Planning reference: 3/2024/0996

Location : 98 Ribchester Road and land adjacent 94 Ribchester Road, Clayton-Le-Dale, BB1 9HQ

Proposal : Approval of details reserved by conditions 9 (SW drainage), 12 (drainage scheme)

PROPOSED DRAINAGE LAYOUT

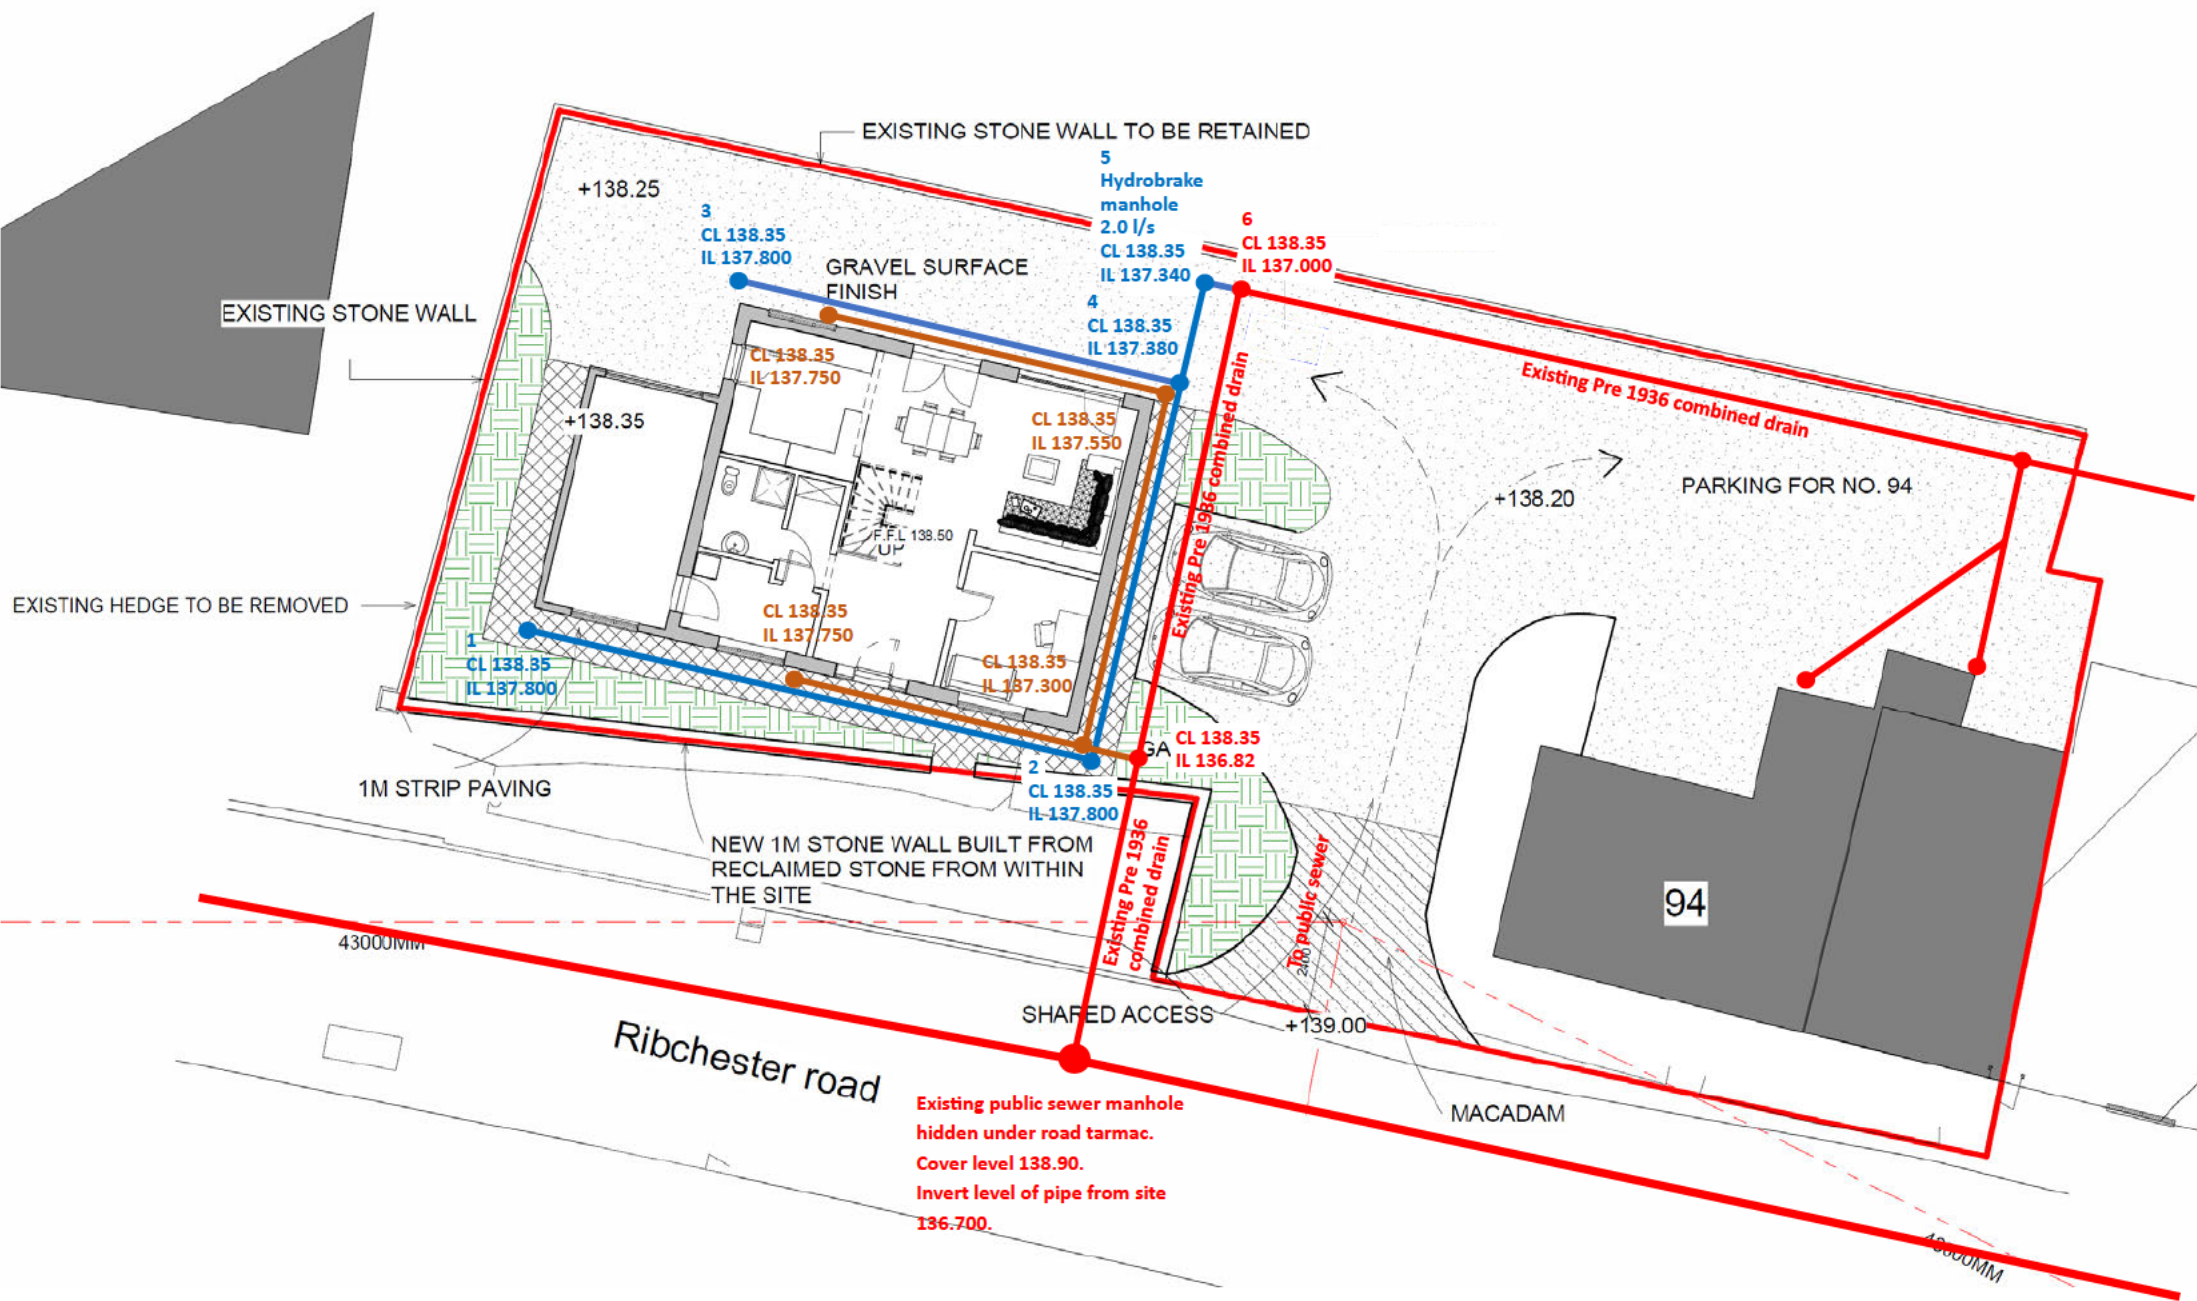
1. It is unclear how the connection is being made with the public wastewater network. We require a detailed drainage plan; clearly demonstrating how the scheme would connect to the public sewer. Noting that this is an application to discharge drainage conditions, we would expect the invert levels and cover levels to be included on the drainage plan.

Response: The drainage plan that was included within the surface and foul water drainage scheme report that was produced in support of the application to discharge the drainage conditions has been revised to provide the information requested above and is attached to this letter.

A drainage survey has been carried out on the drainage within and immediately beyond the development site. It has been proved that the drain leaving the development site under the existing access is connected to the public sewer that lies within Ribchester Road into an

existing manhole that is hidden under the road surfacing. The existing connection enables discharges to be made from the existing site and will be used to enable discharges from the proposed development.

EXISTING DRAINAGE

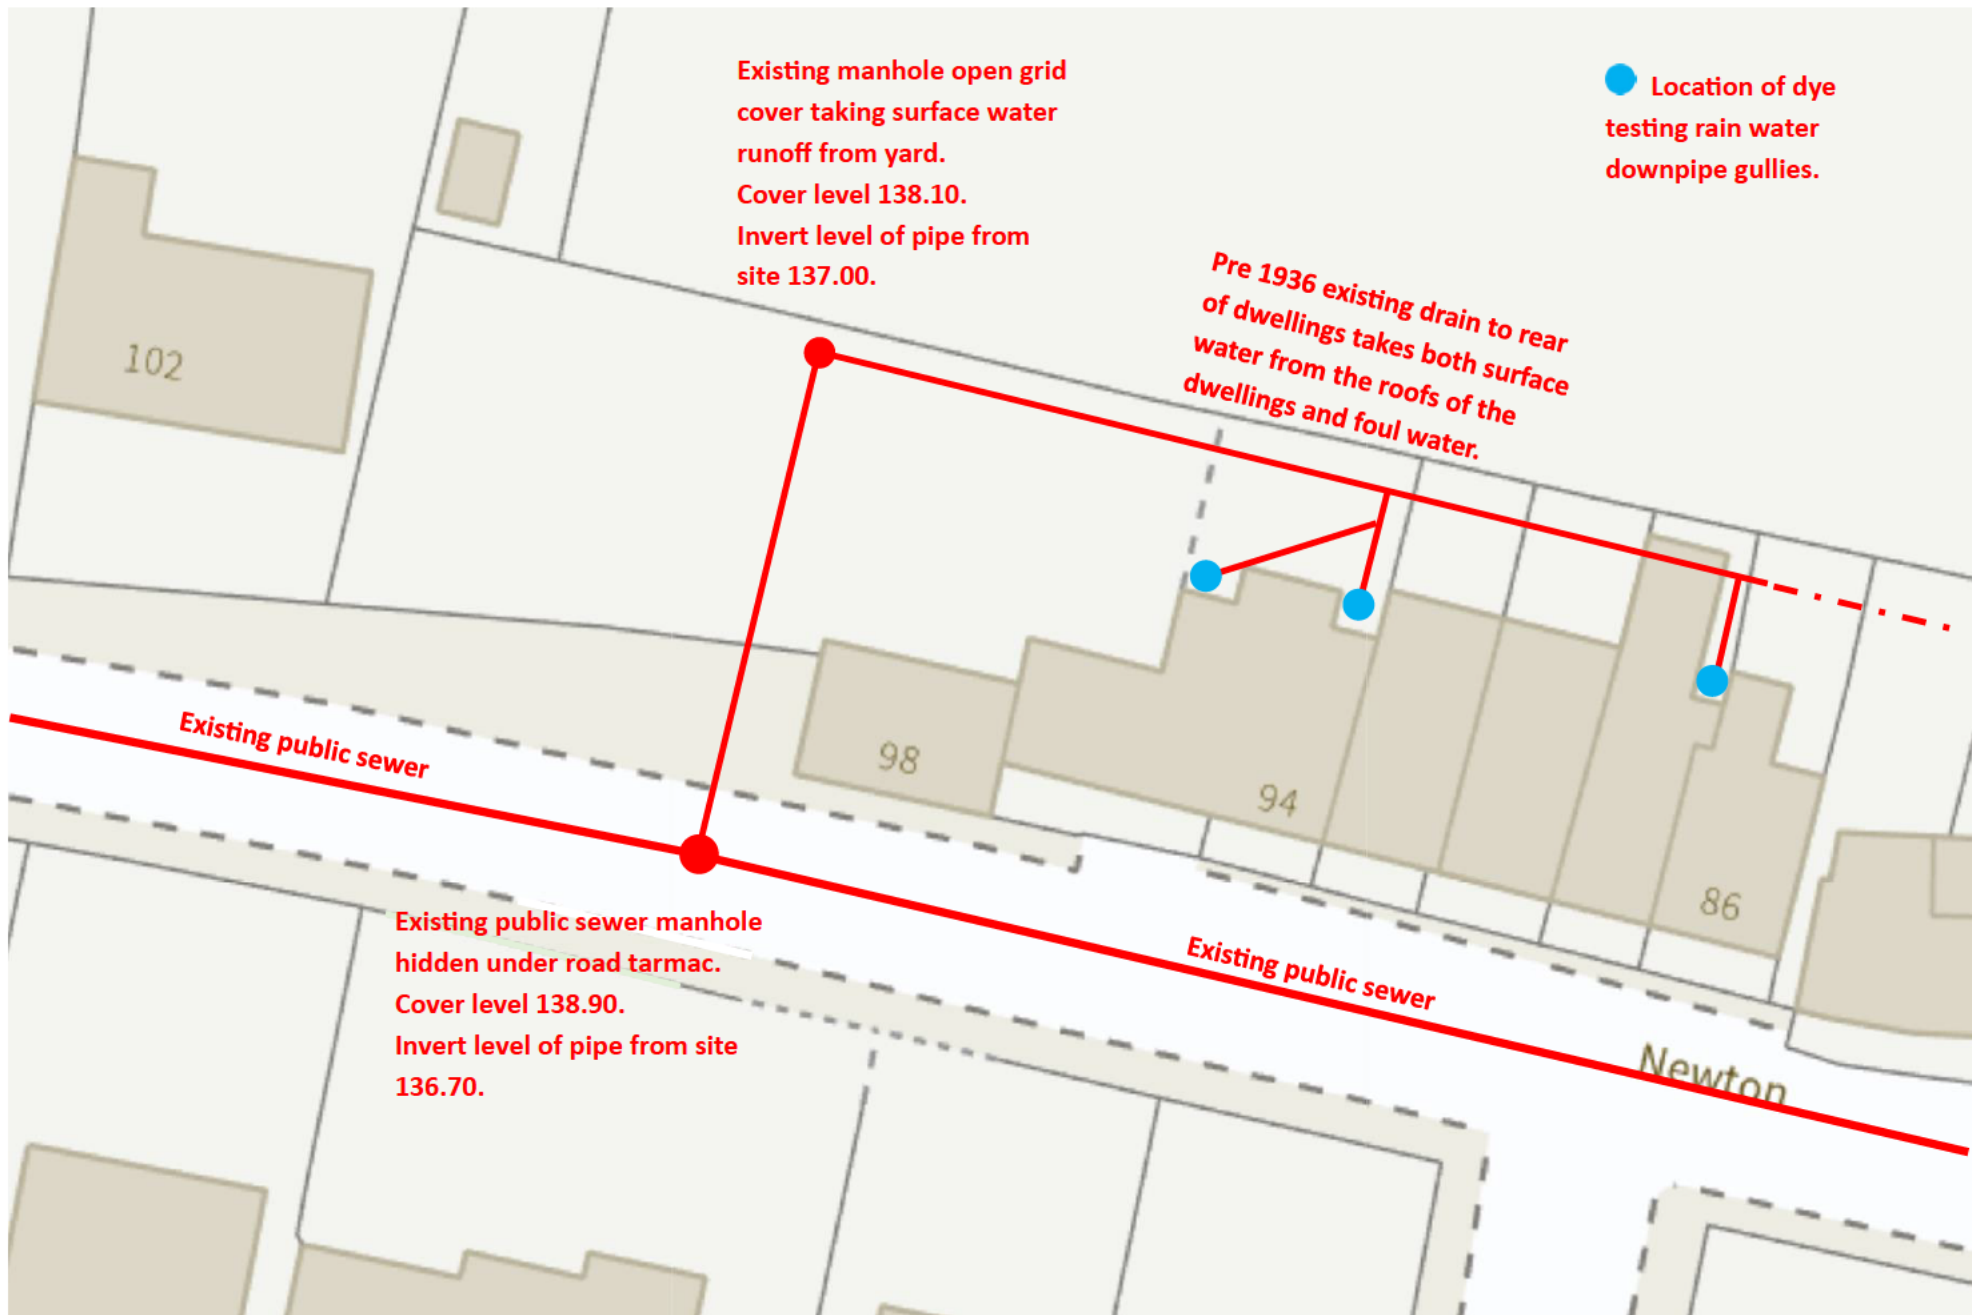
2. The sewer shown on our records is being assumed to be a combined sewer. The asset maps indicate it is a foul only sewer. We require evidence i.e. a drainage survey, to confirm that the foul sewer we have on our records is in fact a public combined sewer.

Response: A drainage survey has been carried out of the drainage within and beyond the application site. The result of the survey is shown on the existing drainage plan attached to this letter.

The drainage within the site extends beyond the site to the east of the site and serves the properties to the east that front onto the northern side of Ribchester Road. Dye testing has been carried out on the gullies taking rainwater from the roofs to the rear of the properties and it has been proved that the drain running along the rear of the existing properties takes both surface and foul water from the existing properties.

As stated above in response to item 1 above, it has been proved that this drain, leaving the development site under the existing access, is connected to the public sewer that lies within Ribchester Road into an existing manhole that is hidden under the road surfacing. As such, the public sewer within Ribchester Road is actually a combined sewer as it is taking both surface water and foul water from the existing properties that lie along the northern side of Ribchester Road. Therefore, under the hierarchy for dealing with surface water runoff from development sites, it is acceptable for surface water runoff to be discharged into it.
